Re: **Violet Hill Gravel Pit, Town of Mono  
Proposed Road Improvements**

Re: **Violet Hill Gravel Pit, Town of Mono**  
**Burnside Review Comments of February 9, 2018**

**Re: Greenwood Pit - Town of Mono  
Peer Review – Traffic Study  
Project No.: 300039415.0000**

**Re: Violet Hill Gravel Pit, Part Lots 30, 31, 32, Concession 4EHS, Town of Mono  
Third Line Entrance Drainage Review**

DESIGN:      CHECKED: MJC      DWG.      **P-1**

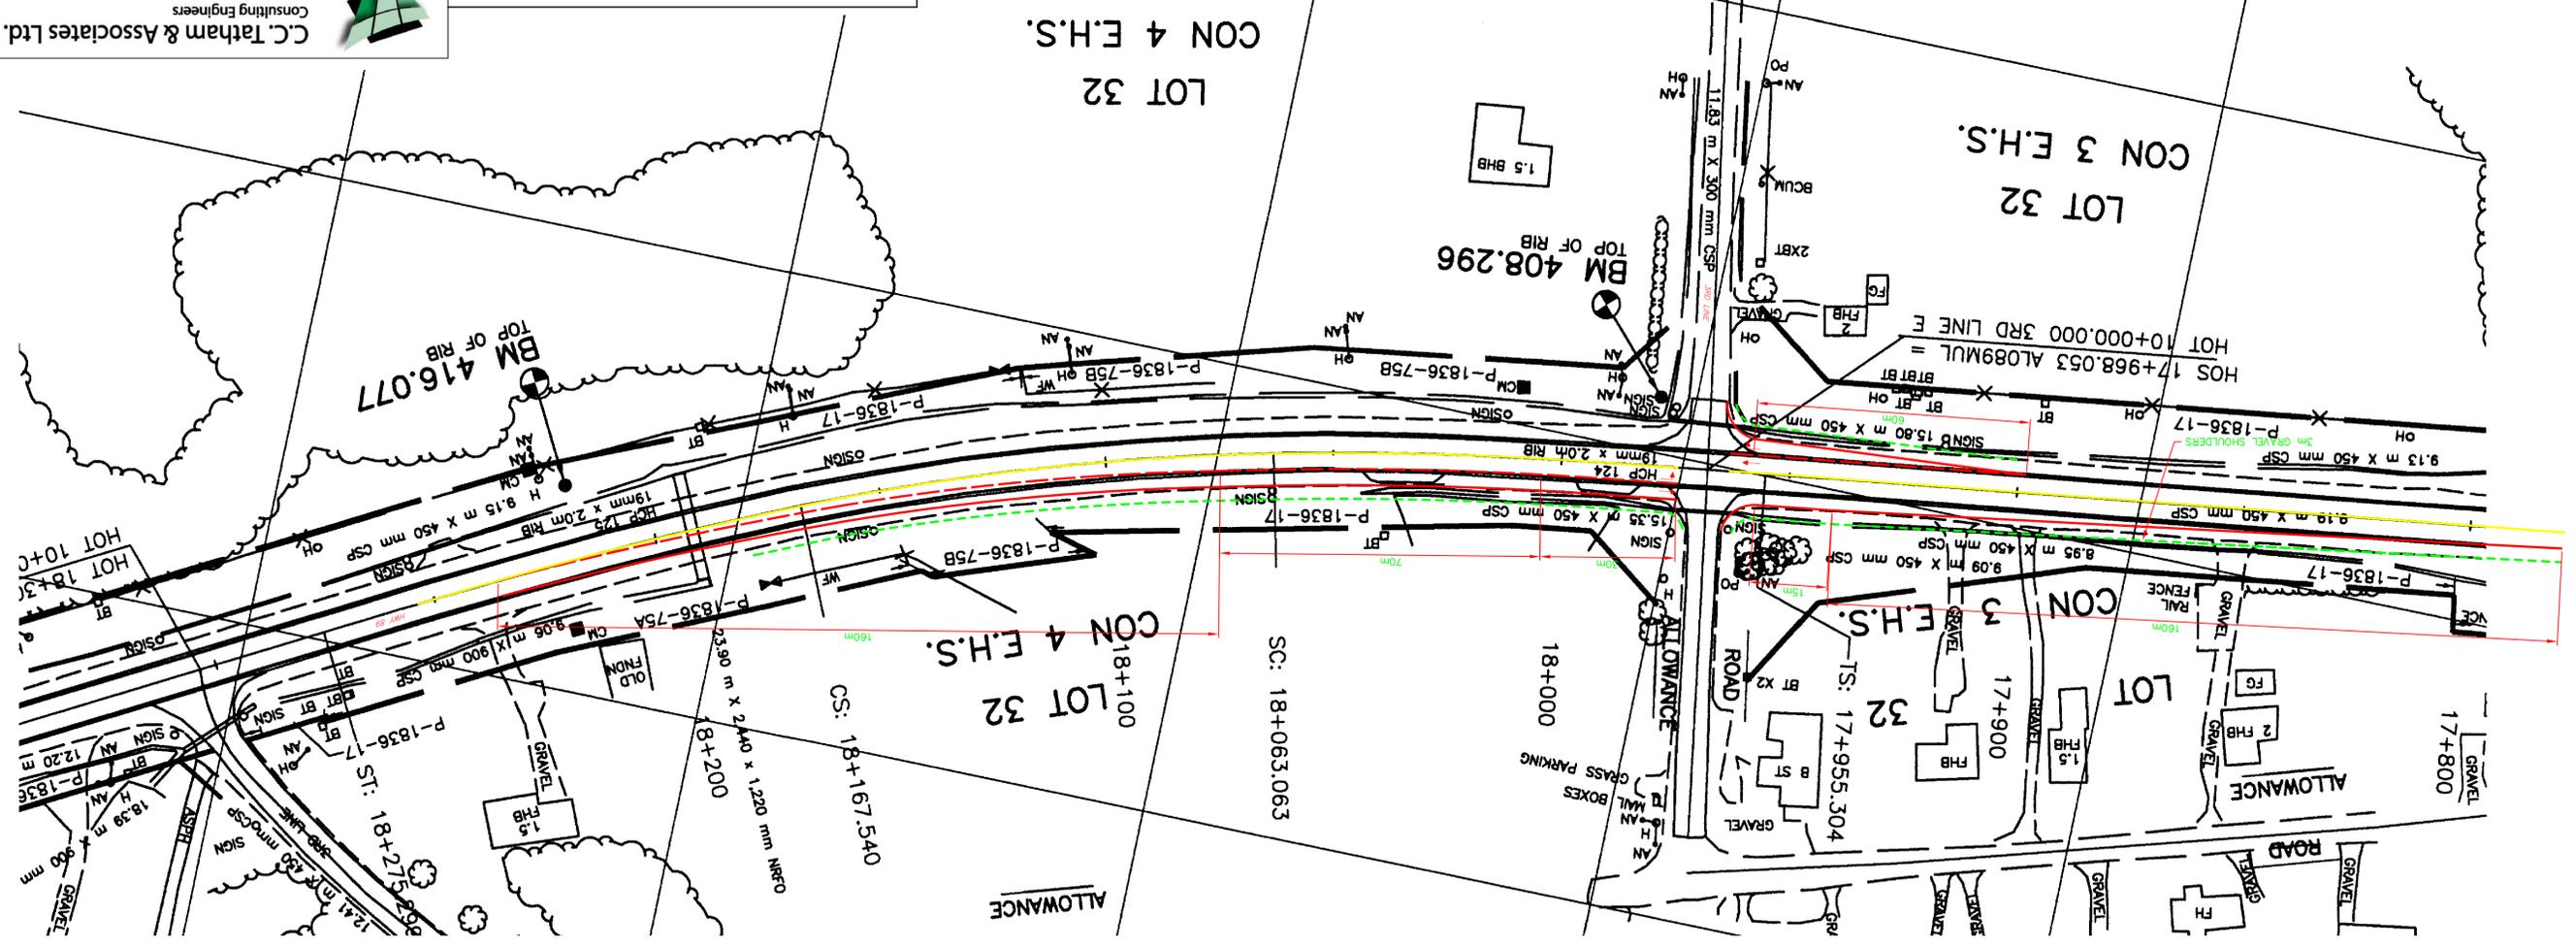
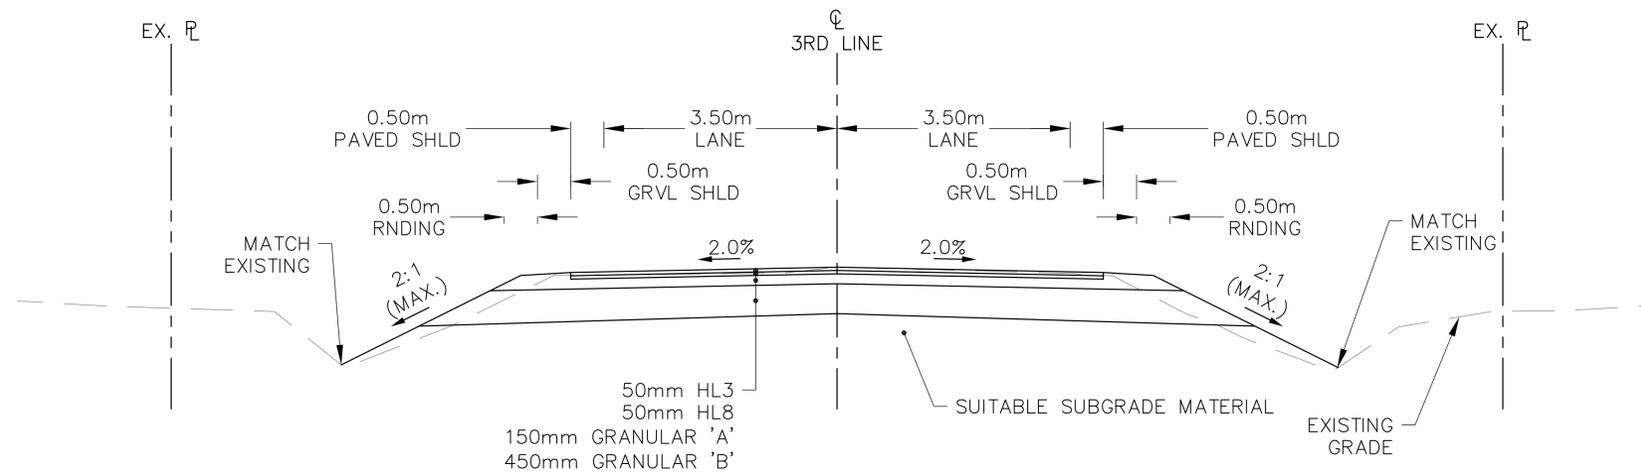
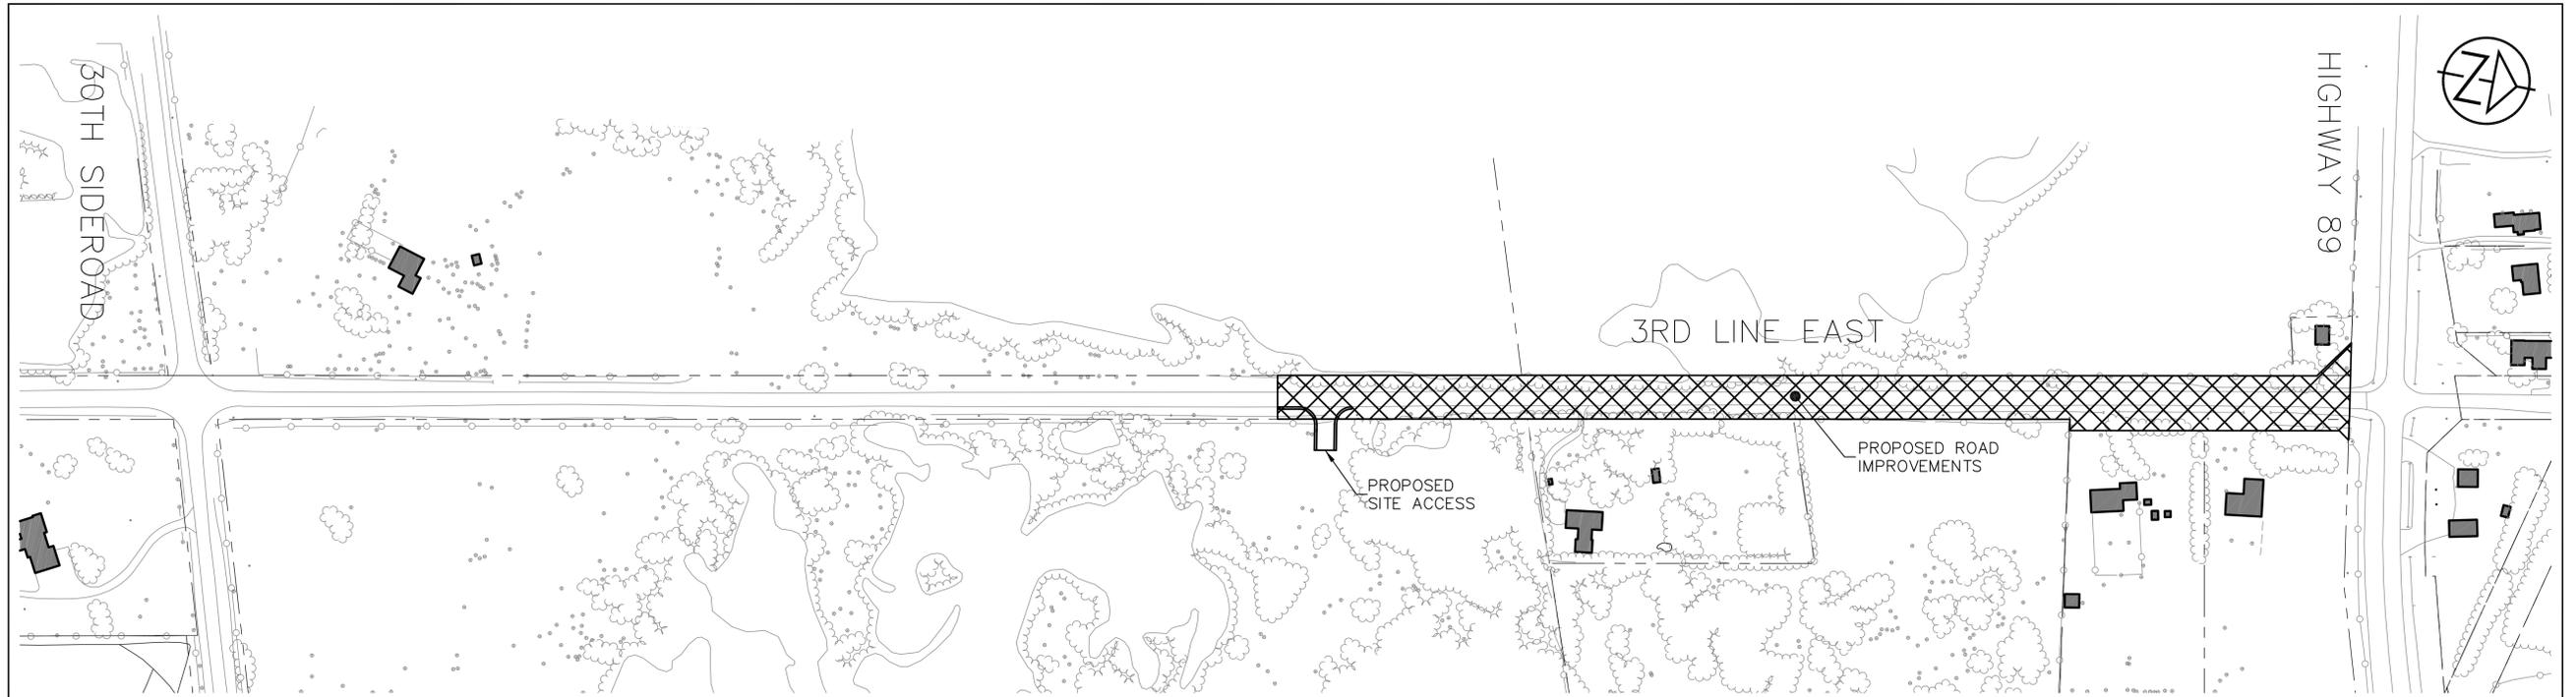
3<sup>rd</sup> Line East is a Town of Mono road with a typical rural cross-section (gravel surface and open roadside ditches). In consideration of its use as a haul route, and to address Town comments, the following improvement are recommended, to extend from Highway 89 to the site access (ie. the portion of 3<sup>rd</sup> Line East that will be designated as a haul route):

- widen and reconstruct the road to provide a 9.0 metre platform width (edge of shoulder to edge of shoulder);
- provide two 3.50 metre lanes (1 lane per direction);
- provide 1.0 metre shoulders on both sides, to be comprised of a 0.5 metre paved shoulder and a 0.5 metre gravel shoulder (to be paved to better protect the edge of road and limit edge breakup); and

- the road structure is to be comprised of 2 lifts of asphalt, 150 millimetres of granular A and 450 millimetres of granular B.

The proposed extents of the improvements to 3<sup>rd</sup> Line East and the corresponding road cross-section are illustrated in Drawing P-1 attached. It is noted that the road structure is a preliminary recommendation only, to be confirmed following geotechnical investigations of the underlying road conditions and in consideration of the anticipated truck volumes and associated loadings. Suffice to say, as the intent of the road improvements is to accommodate truck traffic on a year-round basis, the resulting design will reflect this.

DWG. **AR-1**

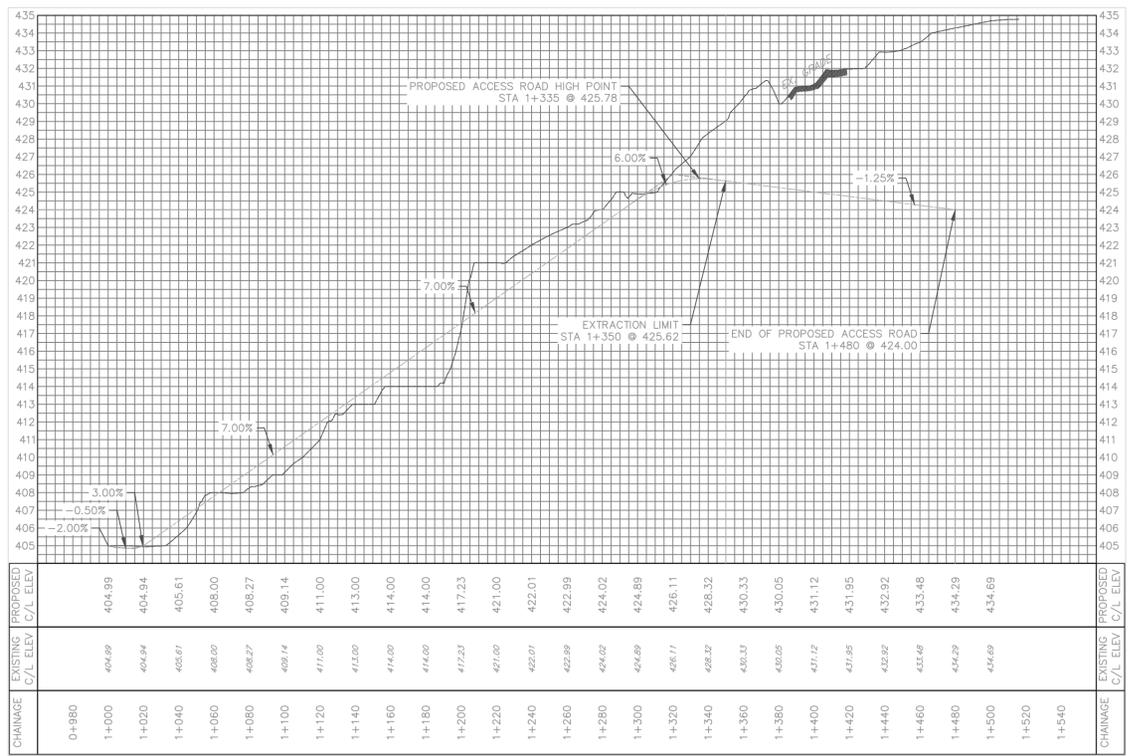
The Erosion Update illustrates on Drawing AR-1 a profile of the driveway. The profile has stationing, but the plan view does not provide stationing; therefore, it is not possible to coordinate between the plan and profile.

The driveway proposes to rise at a grade of 7% from near 3<sup>rd</sup> Line East to where it cuts through the land to access the pit. The driveway rises about 20 m in elevation to where it cuts through the land, which rises another 10 m. If we assume that the edge of 3<sup>rd</sup> Line East is at station 1+1000, then the driveway starts to rise at 7% about 20 m from the edge 3<sup>rd</sup> Line East. Once additional details are provided, it can be reviewed.

The design of the access road has been completed by CCTA and is illustrated on the Access Road Plan (Drawing AR-1) enclosed. The access road enters the site and traverses up the natural draw in the topography at a slope of approximately 7% until it reaches the floor of the first phase of extraction.

Drainage from the area of the access roadway will continue to be directed from east to west down the natural draw in the topography through constructed swales/ditches adjacent to the access roadway towards Concession 3 as it does currently. The surface runoff will continue to drain to the culvert under Concession 3 and ultimately to Sheldon Creek in a manner mimicking existing conditions. The total drainage area draining to the culvert will be less under proposed conditions than existing conditions due to the proposed access road construction.
